Request for Bid	 Marshall University Office of Purchasing One John Marshall Drive Huntington, WV 25755-4100 Direct all inquiries regarding this order to: (304) 696-2599	Bid Number R2101645 - Shewey Building Interior Renovations Addendum No. 01
------------------------	---	--

ADDENDUM NO. 1 May 11, 2021

Marshall University – Shewey Building Interior Renovations

Addendum No. 01
Request for Bid
R2101645 – Shewey Building Interior Renovations
Technical Questions and Answers

6 DETAIL
 A10.1 3" = 1'-0"

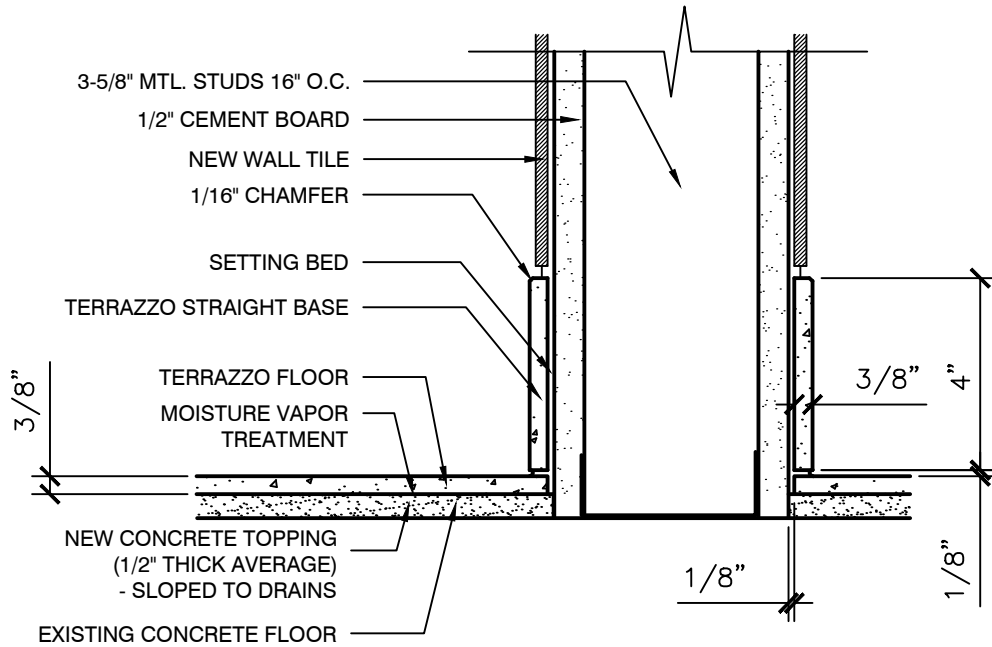
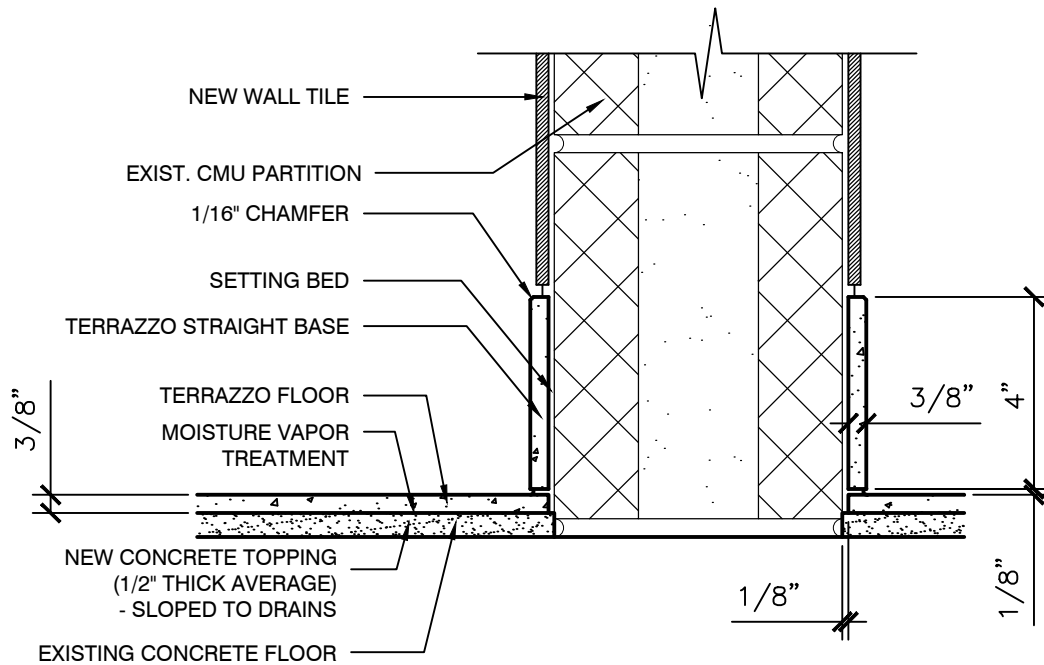
- a. Add Finish General Note “6. In Locker Room Restroom and prior to installation of terrazzo flooring system, install water mitigation system and concrete topping on existing concrete slab and slope to existing drain locations. See revised Details 6/A10.1 and 7/A10.1 and Specifications in Addendum 1.”

c. **A terrazzo straight base on top of the terrazzo floor over the ceramic wall tile is acceptable. See detail in Addendum 1.**

DEMO/LIGHTING -
PART. 1ST & 2ND
FLR PLANS - ELEC

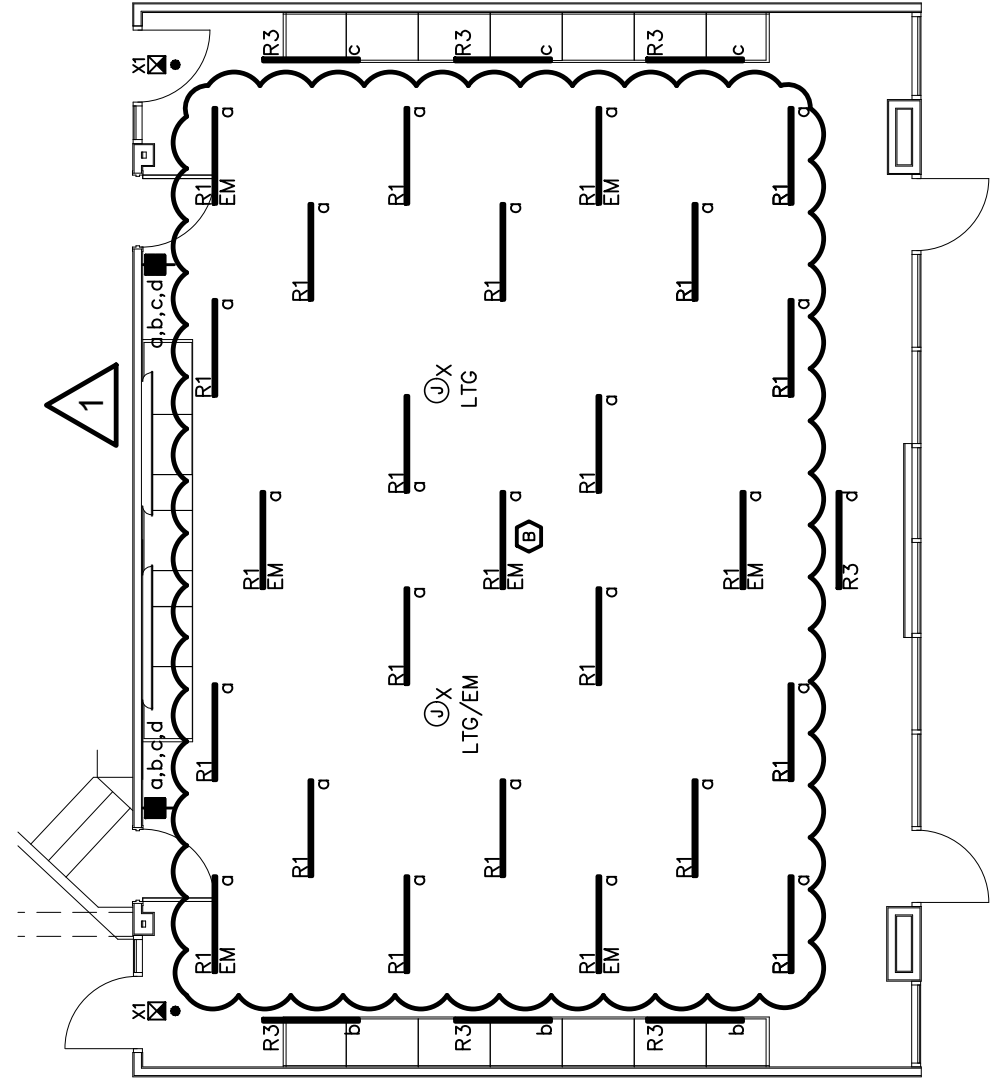
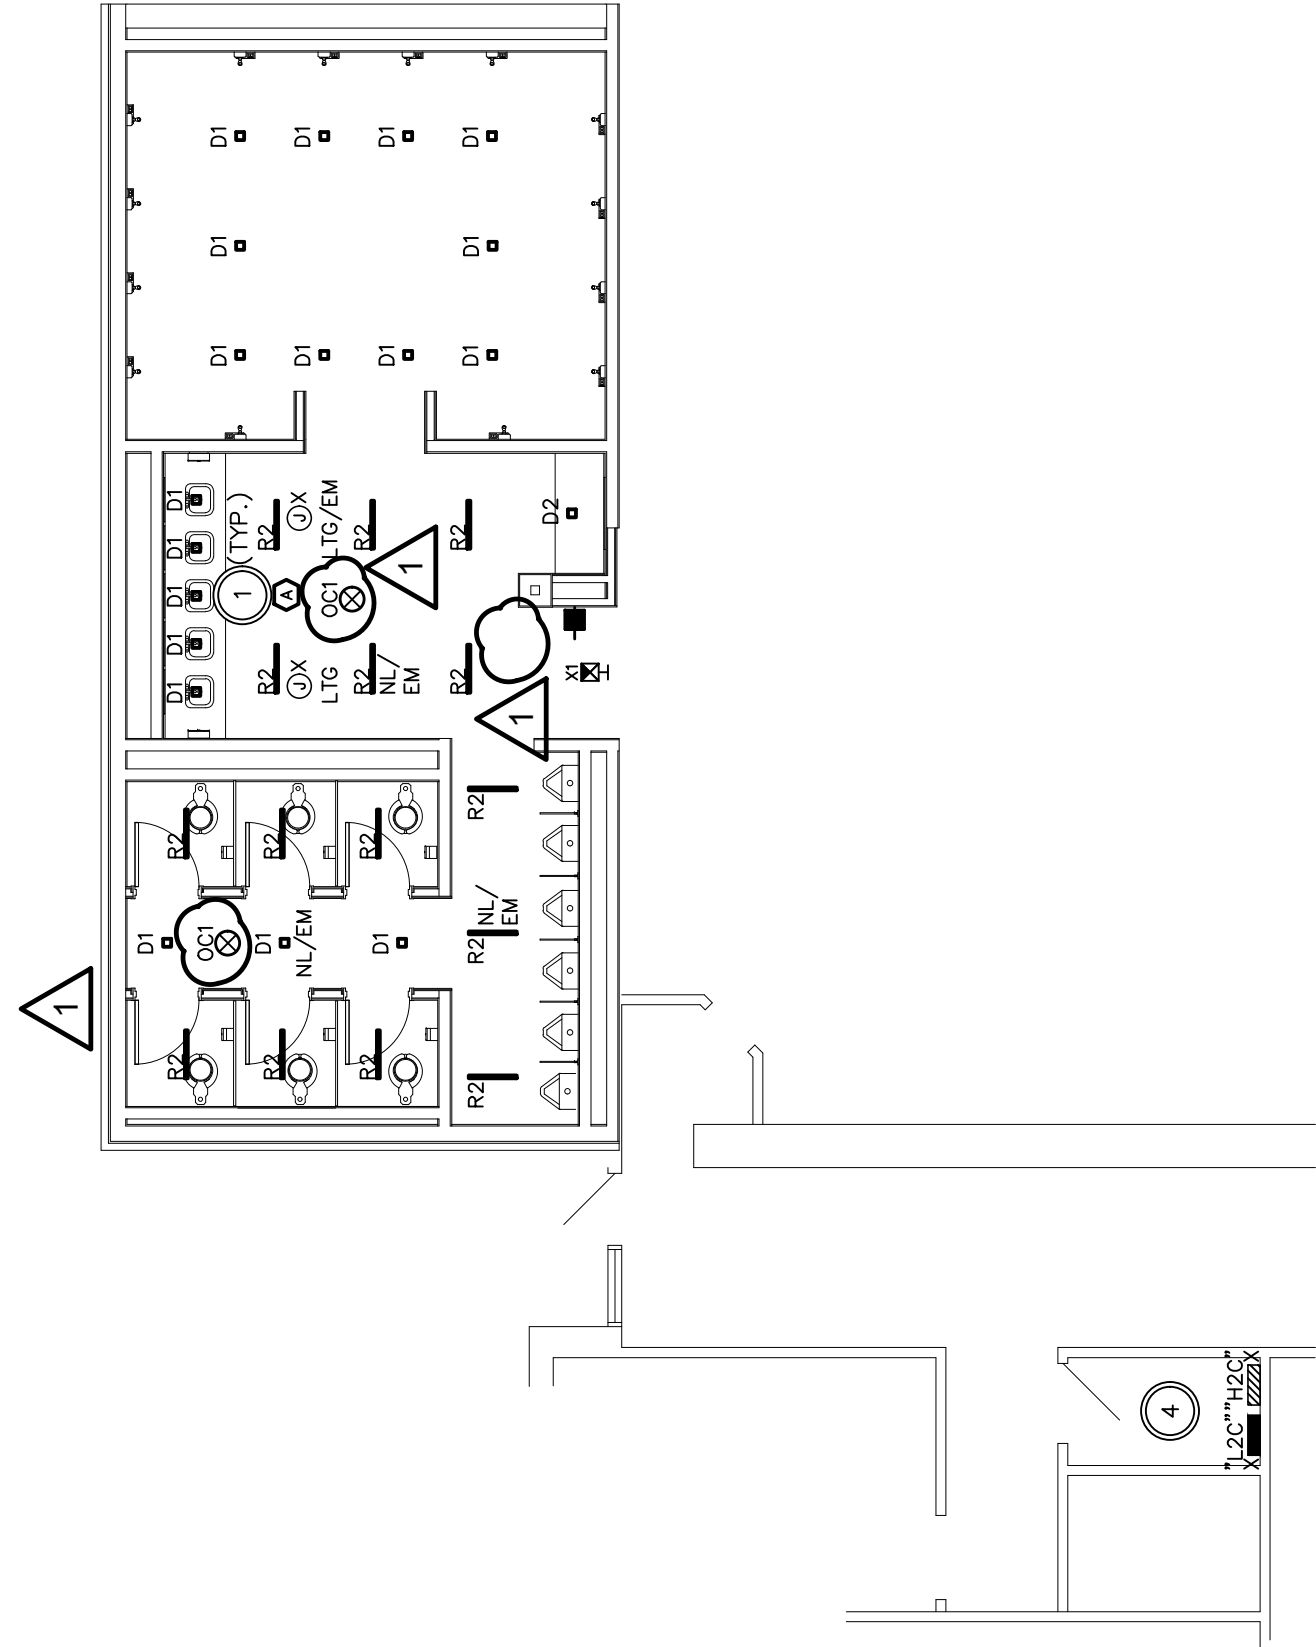
1. Refer to sheet E1 "General Notes and Symbol Legend – Elec"
 - a. Lighting fixture schedule has been revised.
2. Refer to sheet E2 "Demo/Lighting – Part. 1st & 2nd Floor Plans - Elec"
 - a. Occupancy sensor(s) have been added.
 - b. New lighting layout displayed for multi-purpose room.
 - c. Exit sign has been removed.
3. Refer to sheet E4 "Demo/Pwr/Sys – Part. 1st & 2nd Floor Plans - Elec"
 - a. Coded note 8 has been revised.
 - b. Visual strobe in restroom shall be ceiling mounted.

DEMO/PWR/SYS -
PARTIAL 1ST & 2ND
FLR. PLANS - ELEC

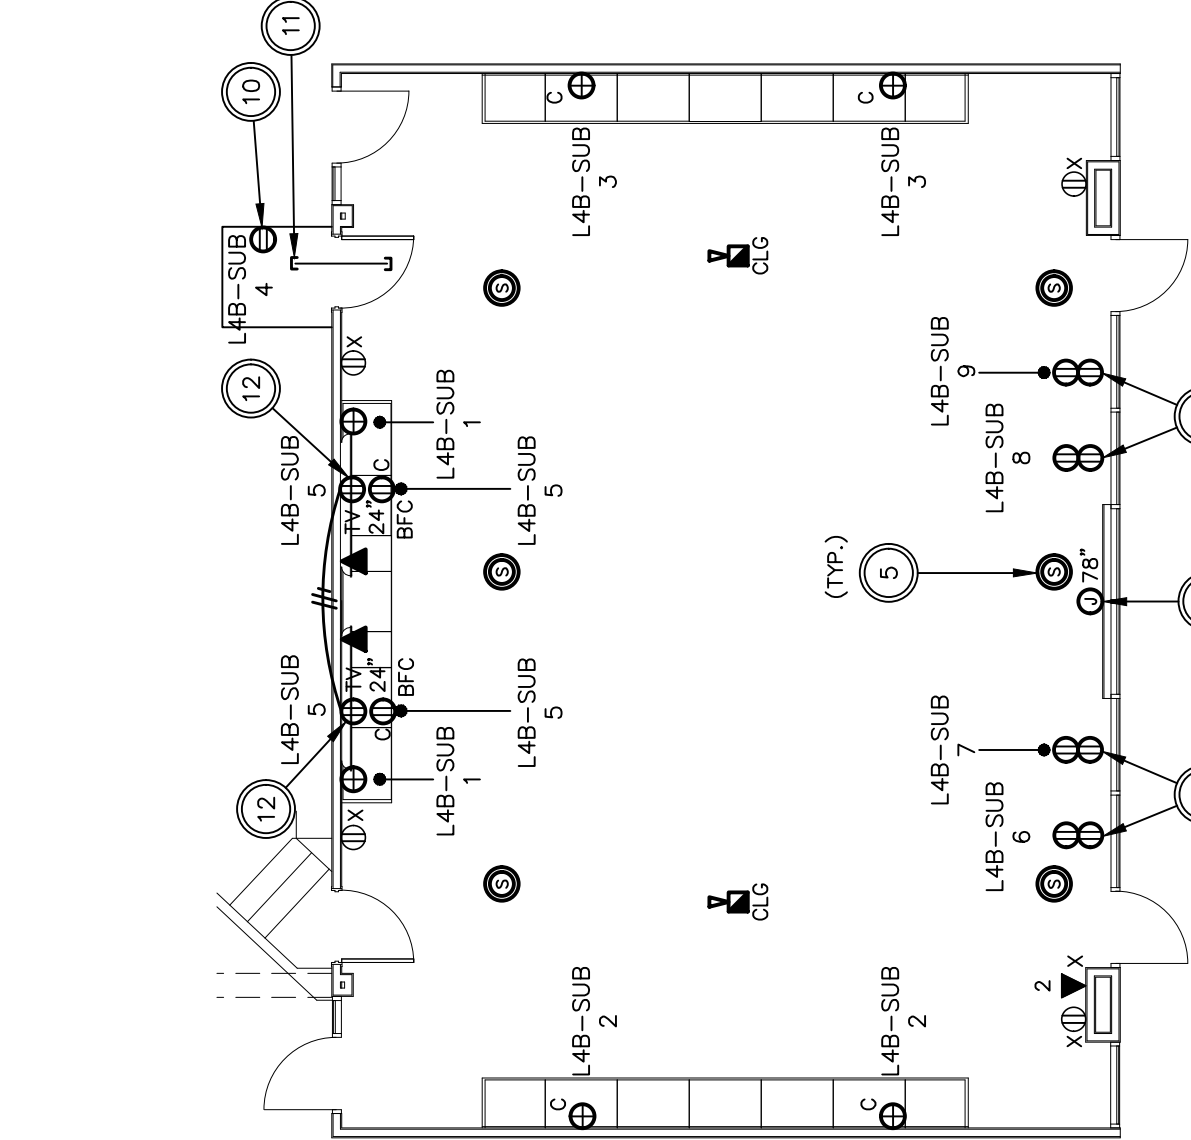
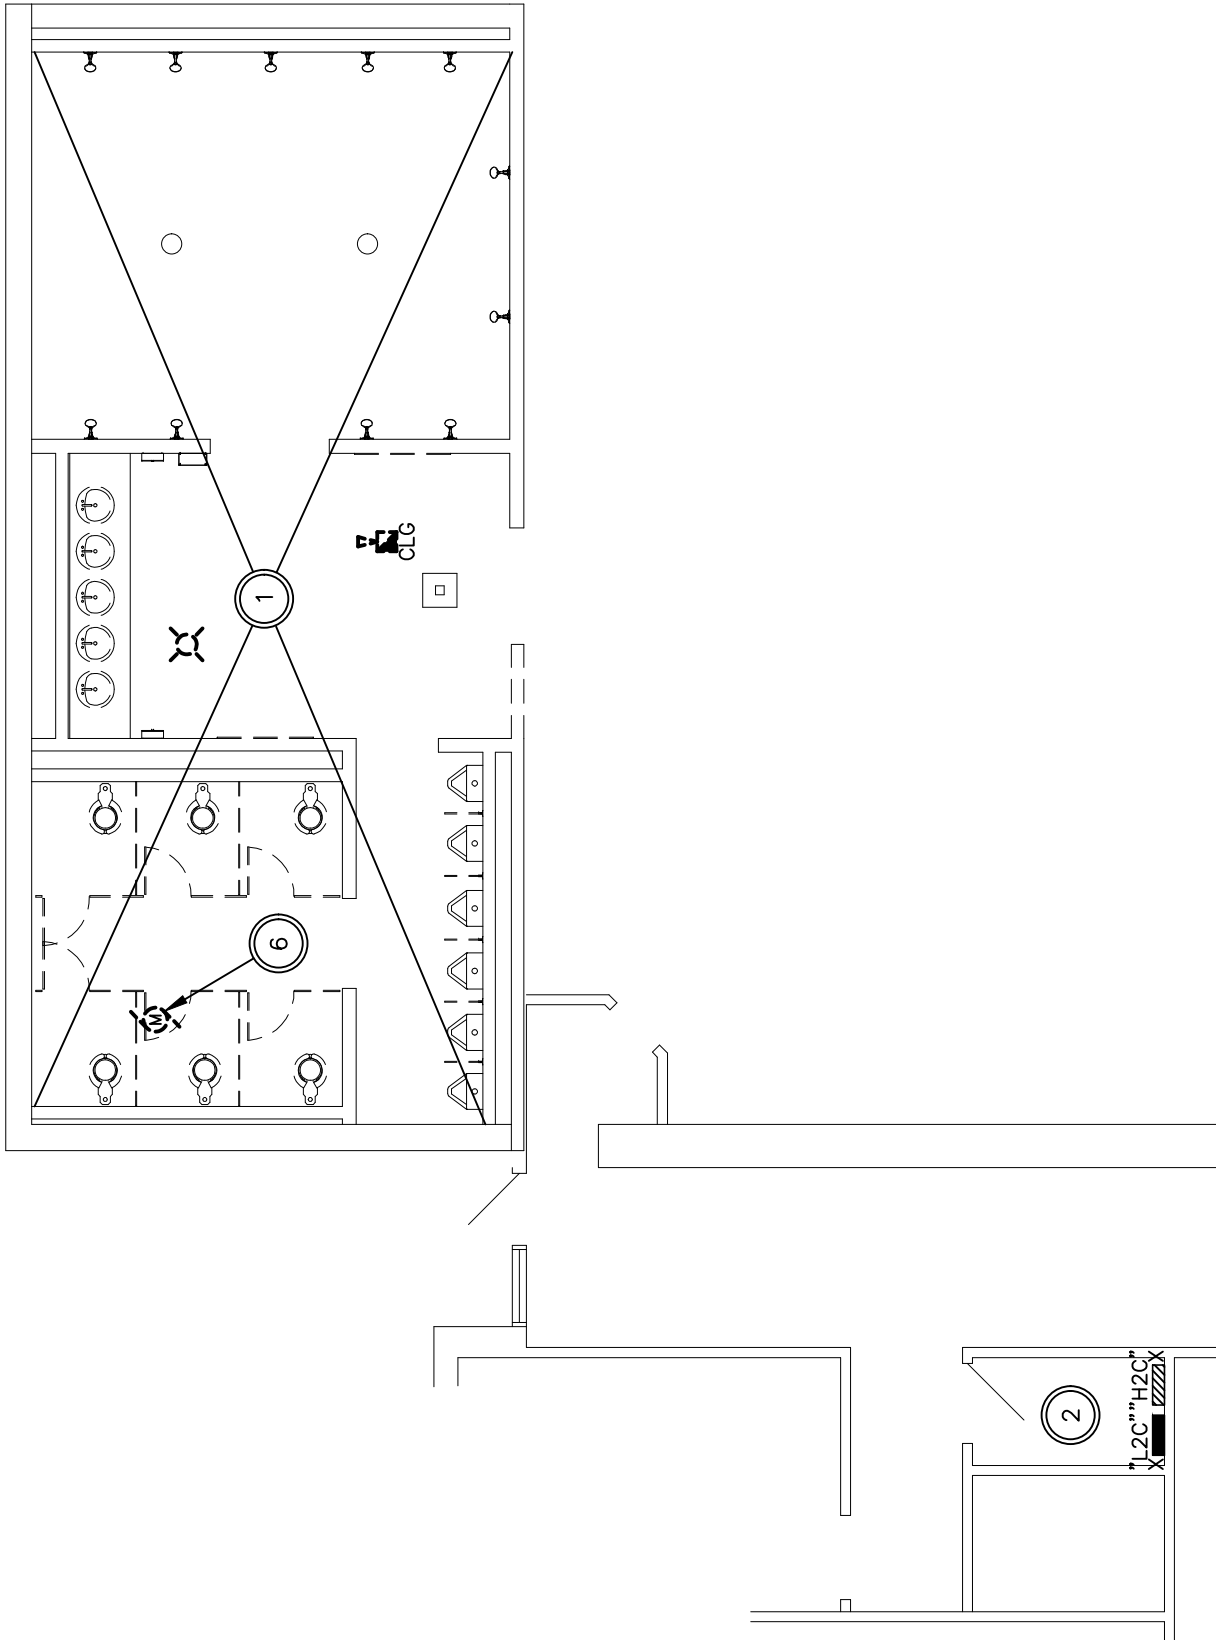
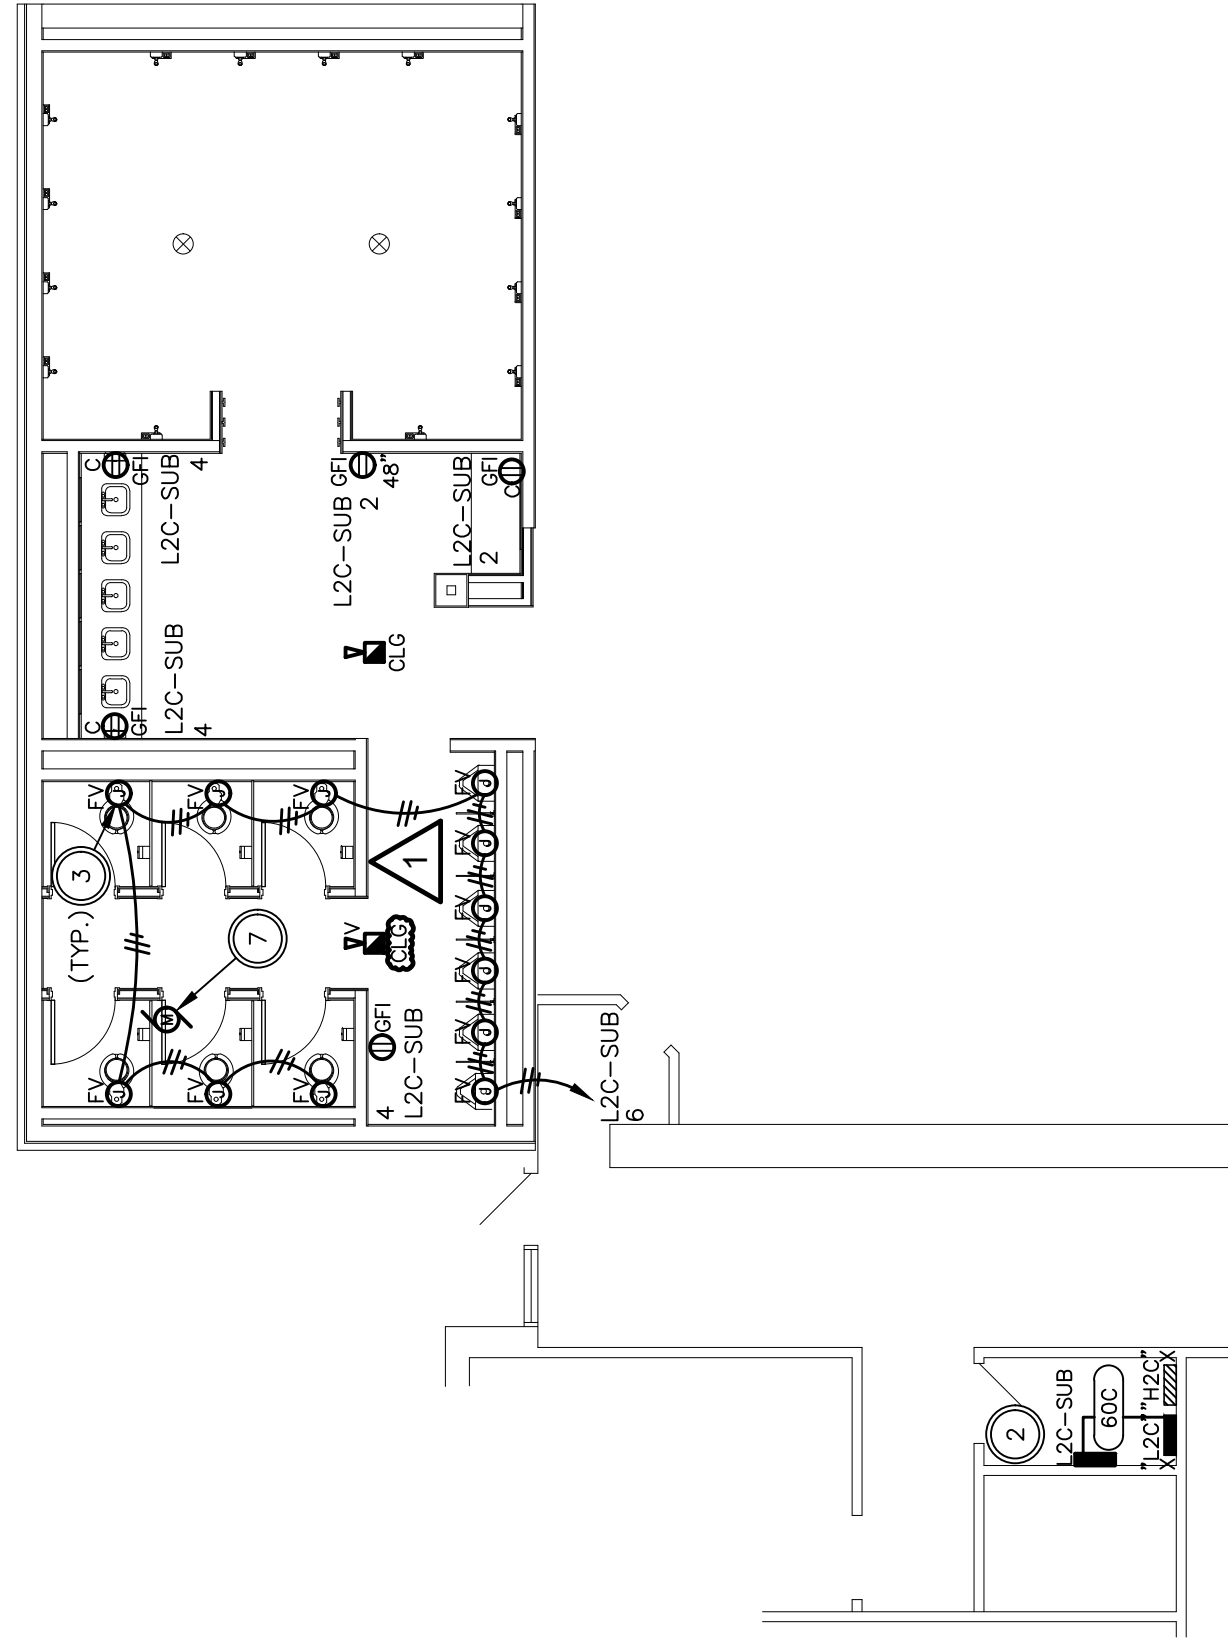
Q12. Can you provide more information about the “wrapped beam” that sheet E3 Note#7 has the new branch circuit conduits passing through?

A12. The intent was to conceal the conduit from view on top of the beam. We did not intend to cut and patch any wall material.
